July 9, 2012

Re: City of Dietrich Environmental Information Document Addendum

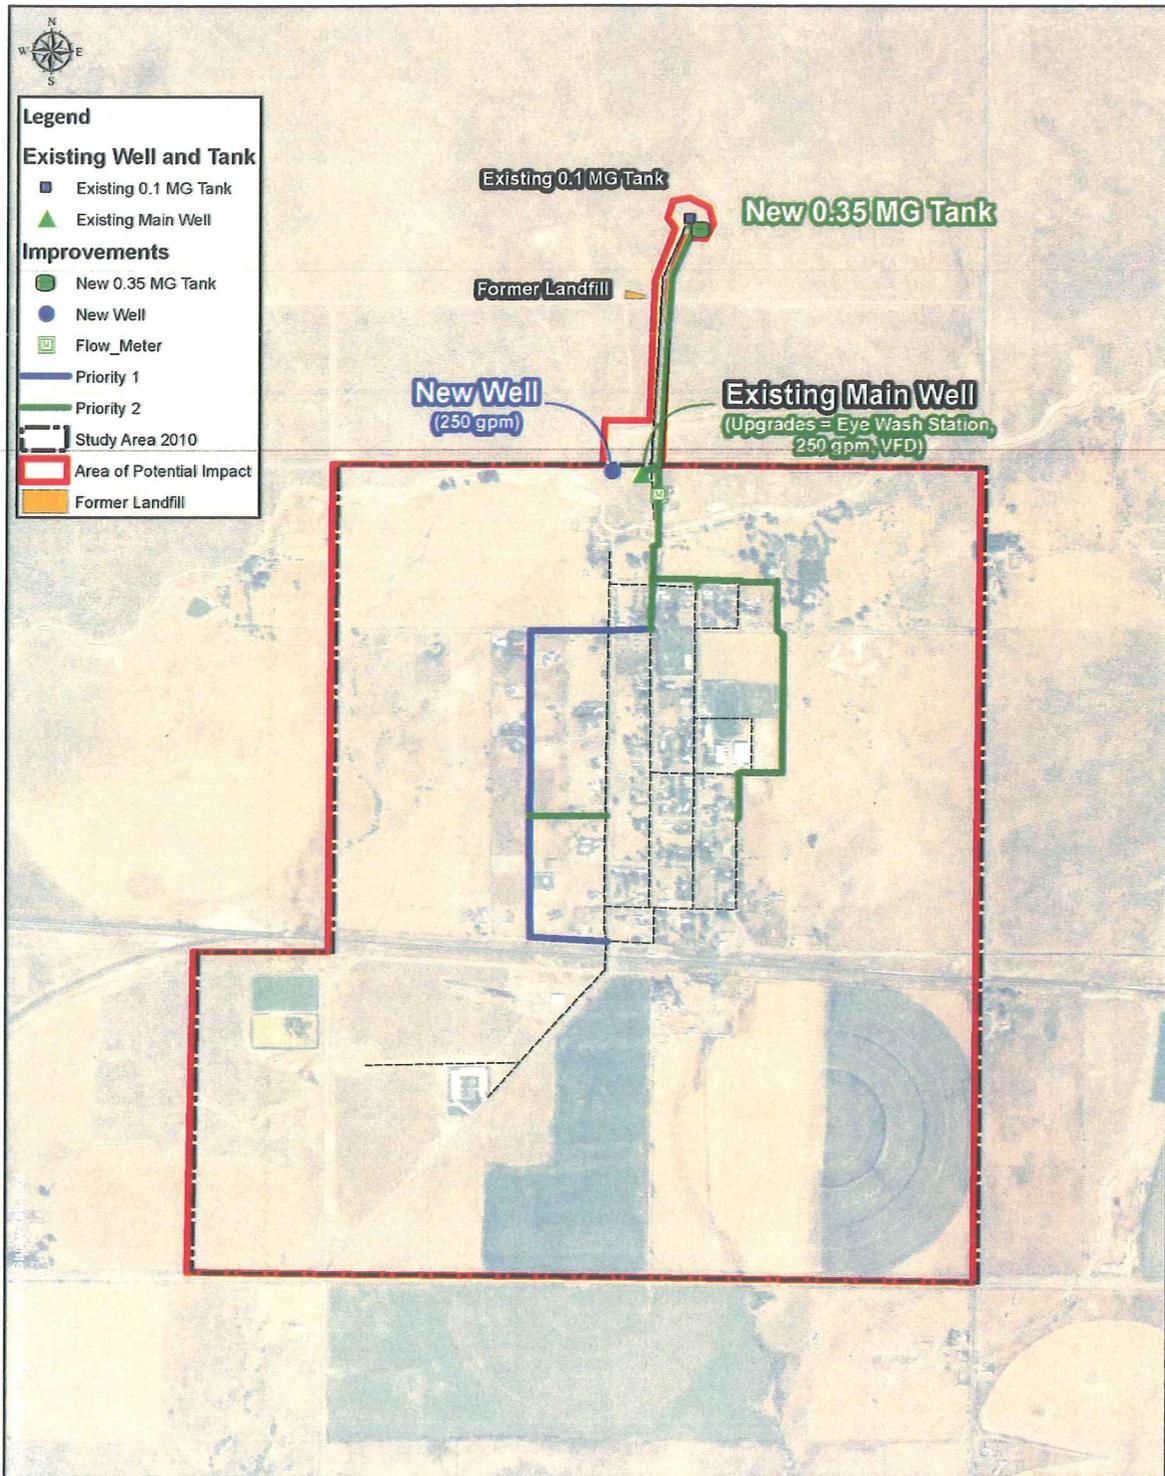
- Add the landfill location to the map showing the PPPA/APE and project features;
- State how the changed well location affects the EID discussion in each of the major points on the EID Checklist section D. I expect that most of this can be handled by a list of the points that are unaffected. At least the following will require some brief discussion: (g) wetlands, (f) floodplains, (i) cultural resources, (n) surface water and ground water and (o) public health (see next bullet). As you pointed out earlier, the archaeological survey included the new well location. The wetlands inventory did not appear to do so, but you should be able to address that with your knowledge of the site.

1st Bullet—The old landfill which is illustrated in the figure below was mentioned during the site walk-through directly after the design kickoff meeting held on April 24, 2012 attended by representatives of DEQ, the design team, City, and the Big Wood River Canal Company.

3rd Bullet—The figure below shows the landfill boundaries and the location of the new well in conjunction with the area of project effect and proposed improvements.

City of Dietrich Estimated Capture Zones and Old Landfill Location

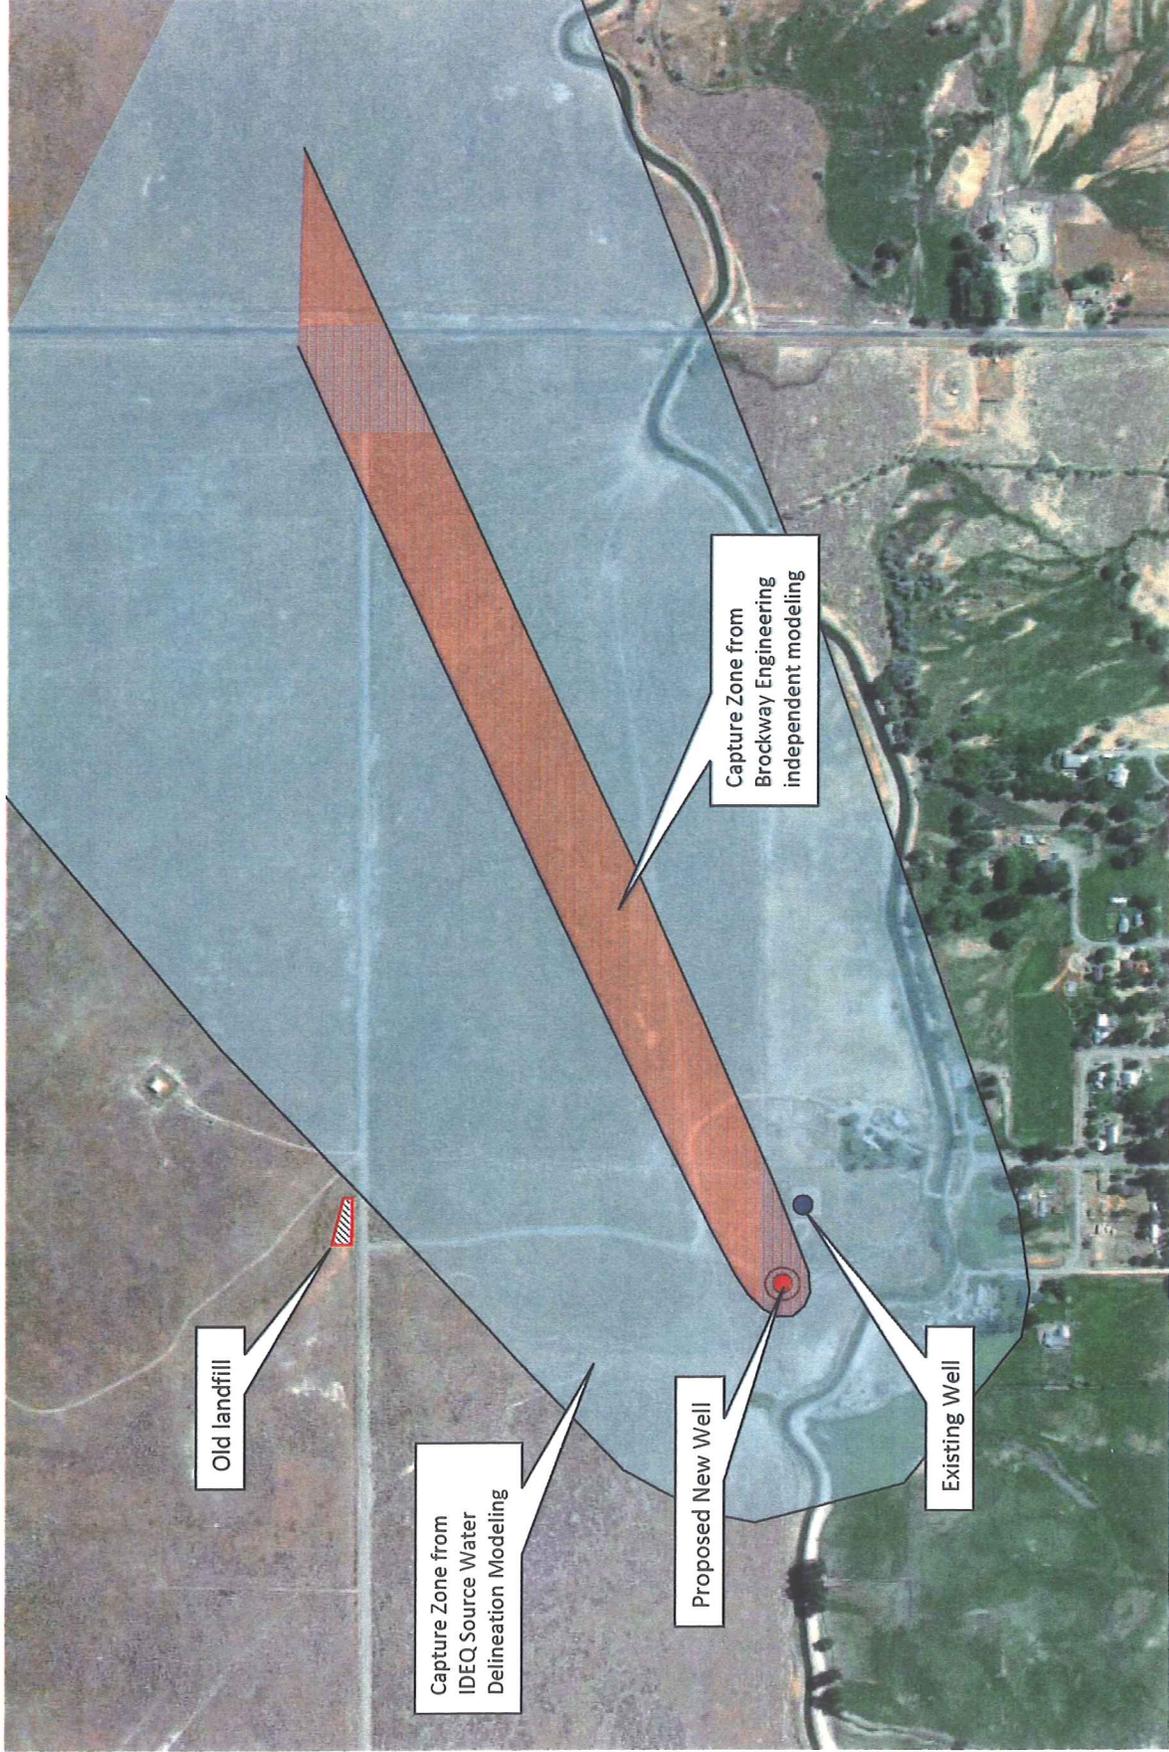
- Include a brief discussion of the groundwater conditions, and Brockway's professional opinion of the likelihood of impacts to the well. I recommend a map showing the landfill location superimposed on the well capture zones from the source water assessment available from www.deq.idaho.gov/water/swaOnline/SearchSwa.aspx. I am attaching the technical report that describes how the ground water modeling was done for that SWA. Your map could look something like this quick-and-dirty figure I put together, but with accurate landfill and well locations.

The capture zone delineated by IDEQ is shown on the attached figure. To place the zone, the capture zone delineated for the existing well was translated or shifted to the new well location. IDEQ had located the existing well too far north, however, so the translation actually resulted in shifting the IDEQ capture zone south-southwesterly about 280 feet. This delineation includes a 10-degree buffer on either side to account for parameter uncertainty and potential underestimation of the extent of the zone.

The capture zone modeled with 130 ft/day has the greatest extent of the three and is shown on the attached figure. Even with the conservatively low hydraulic conductivity of 130 ft/day, and even if a 10-degree buffer were added on each side, the extent of the zone would be much smaller than the IDEQ capture zone. The reason for the major discrepancy is unknown at this time. Further independent evaluation was made using a different model – WinFlow 3.05, an analytical groundwater model similar to WhAEM – with the same parameters as above. The results were similar and the IDEQ capture zones could not be duplicated.

A small, former landfill was situated on BLM land, approximately 1,400 feet north of the proposed well site. The landfill was used chiefly for household refuse from the residents of Dietrich, and was decommissioned in 1985. The landfill site lies wholly outside of the capture zone delineated independently and the capture zone from the IDEQ source water study. Based on this information, the potential for impact on the new well from the landfill activity is minimal.

See accompanying narrative for assumptions regarding capture zone delineations. IDEQ capture zone was translated about 280' south-southwest since the well was not in the correct location.
